JUN 28 1973

Docket No. 50-286

**SMALL BREAK ANALYSES**

TRANSIENT RESPONSE FOLLOWING A LOSS OF NORMAL FEEDWATER WITH ONE 40  
AUXILIARY FEEDWATER PUMP DELIVERY TO TWO STEAM GENERATORS BEGINNING  
AT ONE MINUTE

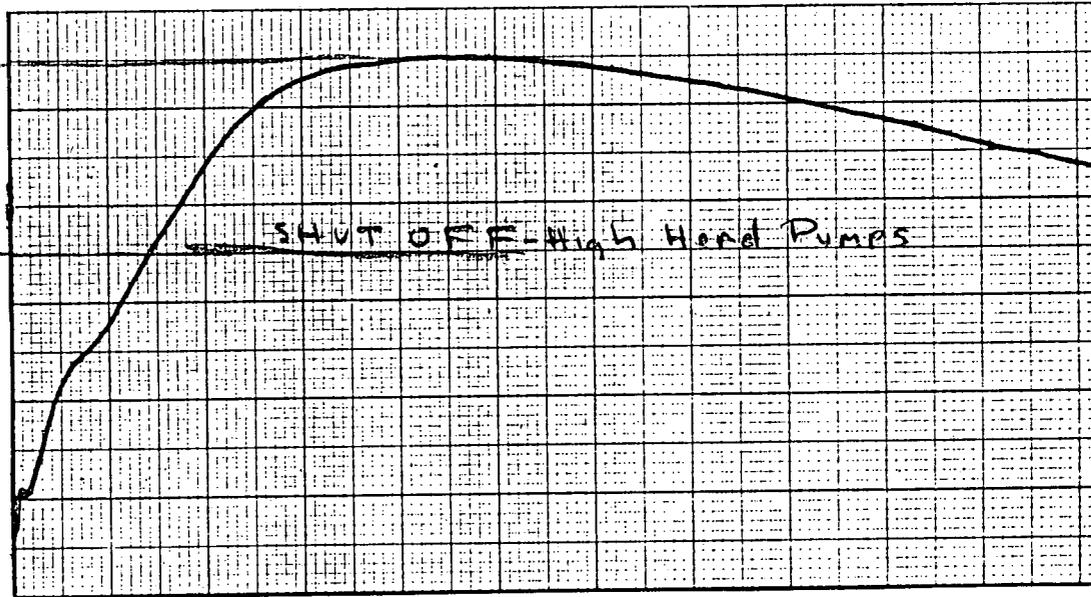
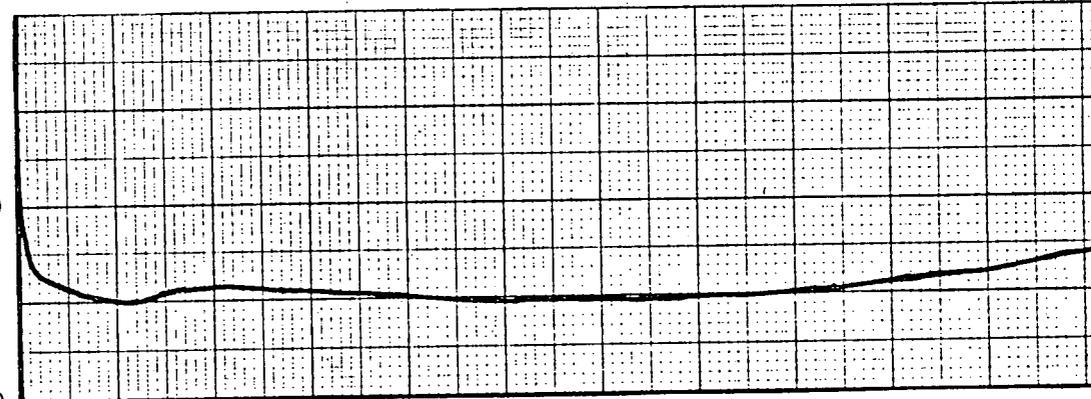
Attached are graphs found in the Indian Point 3 FSAR which show the temperature rise of the primary coolant following a loss of offsite power. The average coolant temperature rises to about 615°F which corresponds to a saturation pressure of around 1720 psia. As shown on the graph, this high saturation temperature and pressure persists for many thousands of seconds after losing offsite power.

I am concerned about a small break, in the zero to two inch range, that might occur during the time of this elevated temperature/pressure condition. The charging pumps on IP-3 are not engineered safety features, so that no water injection will occur until the system pressure is low enough to allow the high head pumps to deliver. These safety injection pumps have a shutoff head of 3375 feet or approximately 1500 psi.

This kind of accident may be worse than the same sized break, immediately followed by a loss of offsite power. I reason that the break after loss of offsite power could be worse than the break before loss of offsite power because at any moment during blowdown the primary system pressure would be higher (corresponding to the higher saturation temperature). Higher primary system pressure ultimately means less pumped injection and a worse core temperature transient. In other words, if the break occurred some 2000 seconds after the power went off, would the primary system pressure at the moment the quiet level equals the top of the core be so high that pumped injection rates are insufficient?

Although this event would have to occur during an infrequent loss of offsite power, say once per year, the product of this frequency times the probability of a small break may exceed the probability of a large pipe break.

Should this accident receive further review?
